FACILITY: LaSalle County Station, Units 1 and 2

SUBJECT: SUMMARY OF DECEMBER 7, 2011, PUBLIC MEETING WITH EXELON GENERATION COMPANY, LLC REGARDING THE PROPOSED EXTENDED POWER UPRATE LICENSE AMENDMENT REQUEST FOR LASALLE COUNTY STATION, UNITS 1 AND 2 (TAC NOS. ME7495 AND ME7496)

**Pre-Application Meeting
Extended Power Uprate**

Annulus Pressurization (AP) Loads Analysis Overview

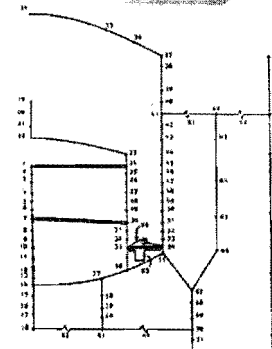
- Based on recent Advisory Committee on Reactor Safeguards comments associated with the use of American National Standards Institute and American Nuclear Society (ANSI/ANS) 58.2-1988 for evaluating jet impingement loads, the NRC staff noted that the use of this standard as it applies to the proposed EPU may be inappropriate. The NRC staff also noted that ANSI/ANS 58.2-1988 is a withdrawn standard.
